# UNITED STATES PATENT AND TRADEMARK OFFICE

10/824,265

**Office Action Summary**

## **DETAILED ACTION**

Figure 8

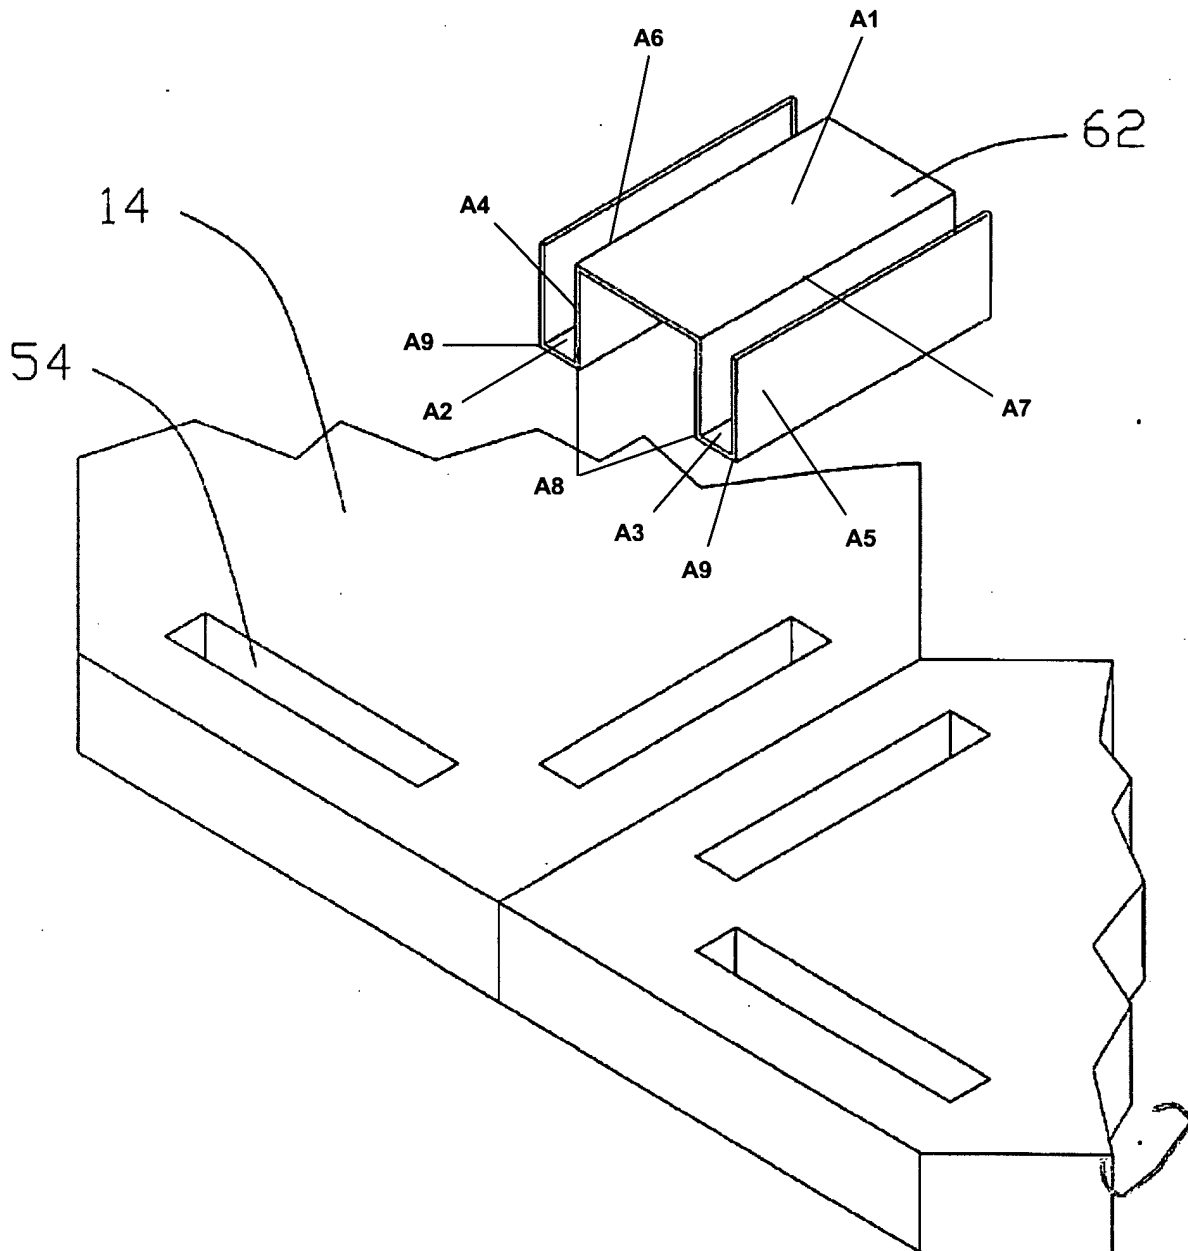
Regarding claim 1, Johnson discloses, in Figure 8, discloses a connector **62** comprising at least one two-prong connector unit comprising an upper member **A1** (see

marked-up attachment), a first lower prong member **A2**, a second lower prong member **A3**, a first joining member **A4**, and a second joining member **A5**. The upper member **A1** has a first end **A6** and a second end **A7**. The first lower prong member **A2** having an inner end **A8** and an outer end **A9**. The second lower prong member **A3** has an inner end **A8** and an outer end **A9**. The first joining member **A4** connects the first end **A6** of the upper member **A1** to the inner end **A8** of the first lower prong member **A2**. The second joining member **A5** connects the second end **A7** of the upper member **A1** to the inner end **A8** of the second joining member **A5**. The upper member **A1** is substantially parallel to the first lower prong member **A2** and to the second lower prong member **A3**.

Regarding claim 16, Johnson discloses, in Figure 8, a system comprising adjacent mat panels **14** and a connector **62**. The mat panels **14** have a hole **54** near edges. The connector **62** is inserted into the holes **54**. The connector **62** has at least one two-prong connector unit comprising an upper member **A1** (see marked-up attachment), a first lower prong member **A2**, a second lower prong member **A3**, a first joining member **A4**, and a second joining member **A5**. The upper member **A1** has a first end **A6** and a second end **A7**. The upper member **A1** lies on top of the mat panels **14** and spans the distance between the holes **54** in the adjacent mat panels **14**. The first lower prong member **A2** has an inner end **A8** and an outer end **A9**. The second lower prong member **A3** has an inner end **A8** and an outer end **A9**. The first joining member **A4** connects the first end **A6** of the upper member **A1** to the inner end **A8** of

Regarding claims 9 and 22, the first lower prong member **A2**, the second lower prong member **A3**, the first joining member **A4**, and the second joining member **A5** are comprised of a raw material selected from metal sheets.

**FIG. 5**

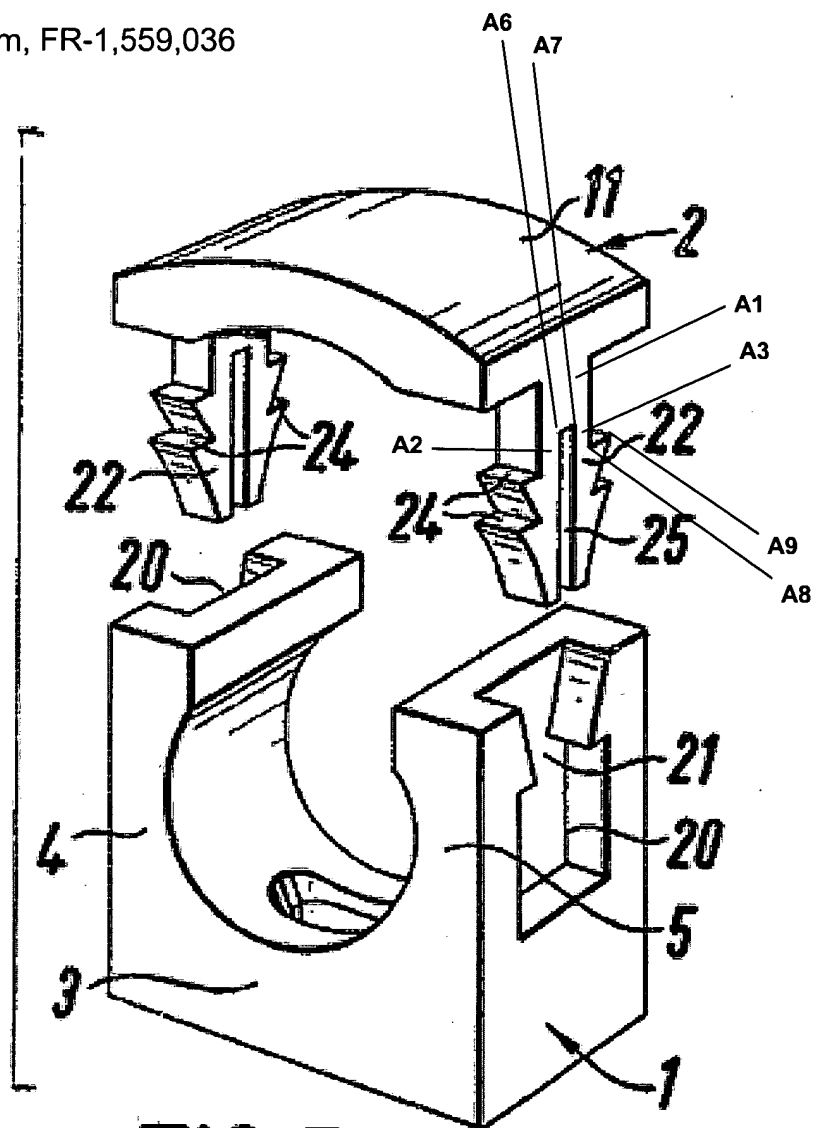
Regarding claim 1, Dom discloses, in Figure 5, discloses a connector **2** having at least one two-prong connector unit comprising an upper member **A1** (see marked-up attachment), a first lower prong member **22**, a second lower prong member **22**, a first joining member **A2**, and a second joining member **A3**. The upper member **A1** has a first end **A6** and a second end **A7**. The first lower prong member **22** having an inner end **A8** and an outer end **A9**. The second lower prong member **22** has an inner end **A8** and an outer end **A9**. The first joining member **A2** connects the first end **A6** of the upper member **A1** to the inner end **A8** of the first lower prong member **22**. The second joining member **A3** connects the second end **A7** of the upper member **A1** to the inner

Regarding claim 30, Dom discloses, in Figure 5, discloses a connector **2** having at least one two-prong connector unit comprising an upper member **A1** (see marked-up attachment), a second upper member **A1**, a first lower prong member **22**, a second lower prong member **22**, a first joining member **A2**, a second joining member **A3**, a third lower prong member **22**, a fourth lower prong member **22**, a third joining member **A4**, a fourth joining member **A5**, and at least one spanning member **11**. The upper member **A1** has a first end **A6** and a second end **A7**. The first lower prong member **22** having an inner end **A8** and an outer end **A9**. The second lower prong member **22** has an inner end **A8** and an outer end **A9**. The first joining member **A2** connects the first end

Fig. 5.

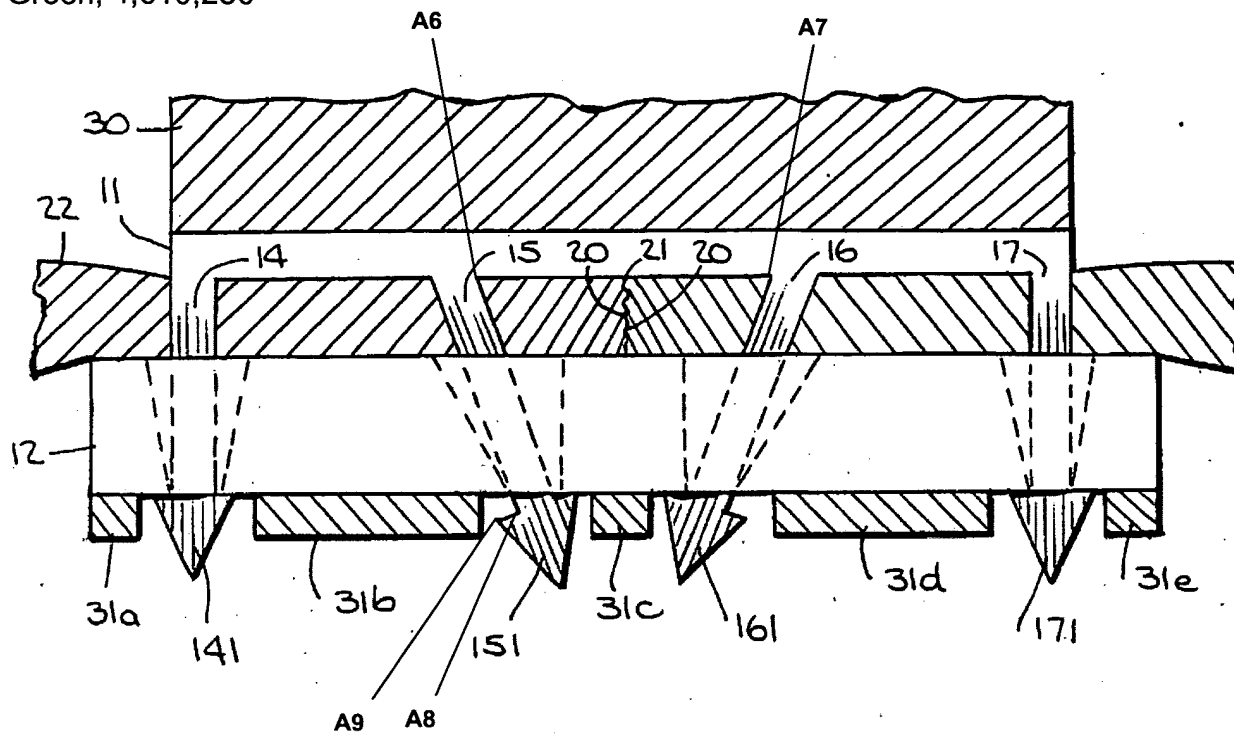
Regarding claim 1, Green discloses, in Figure 5, discloses a connector having at least one two-prong connector unit **11** comprising an upper member **13**, a first lower

prong member **151**, a second lower prong member **161**, a first joining member **15**, and a second joining member **16**. The upper member **13** has a first end **A6** (see marked-up attachment) and a second end **A7**. The first lower prong member **151** having an inner end **A8** and an outer end **A9**. The second lower prong member **161** has an inner end **A8** and an outer end **A9**. The first joining member **15** connects the first end **A6** of the upper member **13** to the inner end **A8** of the first lower prong member **151**. The second joining member **16** connects the second end **A7** of the upper member **13** to the inner end **A8** of the second joining member **16**. The upper member **13** is substantially parallel to the first lower prong member **151** and to the second lower prong member **161**.

Regarding claim 6, an internal angle between the upper member **13** and the first joining member **15** is less than ninety degrees and an internal angle between the upper member **13** and the second joining member **16** is less than ninety degrees.

**FIG. 8A**

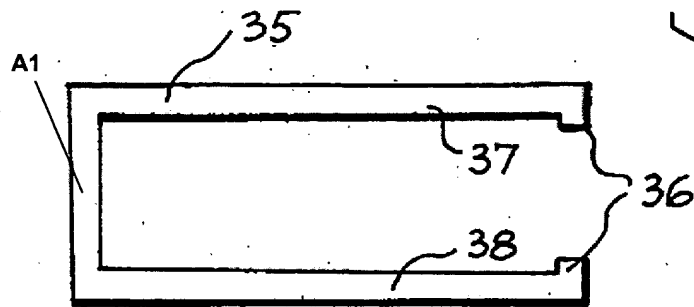
Regarding claim 16, Brown discloses, in Figures 8A and 8B, a system comprising adjacent mat panels **13** and a connector **35**. The mat panels **13** have a hole **14** near edges. The connector **35** is inserted into the holes **14**. The connector **35** has at least one two-prong connector unit comprising an upper member **A1** (see marked-up

attachment), a first lower prong member **36**, a second lower prong member **36**, a first joining member **37**, and a second joining member **38**. The upper member **A1** has a first end and a second end. The upper member **A1** lies on top of the mat panels **13** and spans the distance between the holes **14** in the adjacent mat panels **13**. The first lower prong member **36** has an inner end and an outer end. The second lower prong member **36** has an inner end and an outer end. The first joining member **37** connects the first end of the upper member **A1** to the inner end of the first lower prong member **36**. The second joining member **38** connects the second end of the upper member **A1** to the inner end of the second joining member **38**. The upper member **A1** is substantially parallel to the first lower prong member **36** and to the second lower prong member **36**.

Regarding claim 20, the internal angle between the upper member **A1** and the first joining member **37** is at least ninety degrees and the internal angle between the upper member **A1** and the second joining member **38** is at least ninety degrees.
